UNITED STATES PATENT AND TRADEMARK OFFICE

| 10/730,834 | 12/08/2003 | Nick Kuo | JCLA11759 | 5204 |

Office Action Summary

DETAILED ACTION

FIG.3

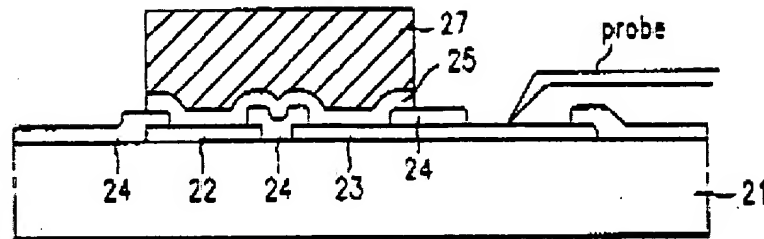
Elenius does not teach a testing pad or second portion used to be in contact with a testing probe and/or a patterned circuit layer comprising a gold layer. Therefore, Elenius in view of Kim does not teach that the gold layer has a thickness greater than one micron. Nevertheless, Kim (e.g. fig. 3) shows a patterned circuit layer connected to a top surface through an opening wherein the patterned circuit layer comprises a first portion used to have a bump 27 formed thereover and a second portion to be in contact with a testing probe whereon the first portion is connected to the second portion. This type of embodiment prevents decreases in testing reliability caused by damages on the surface of the bump and polluting material thereby enhancing its yield with respect to bonding (col. 2/lls. 10-30).
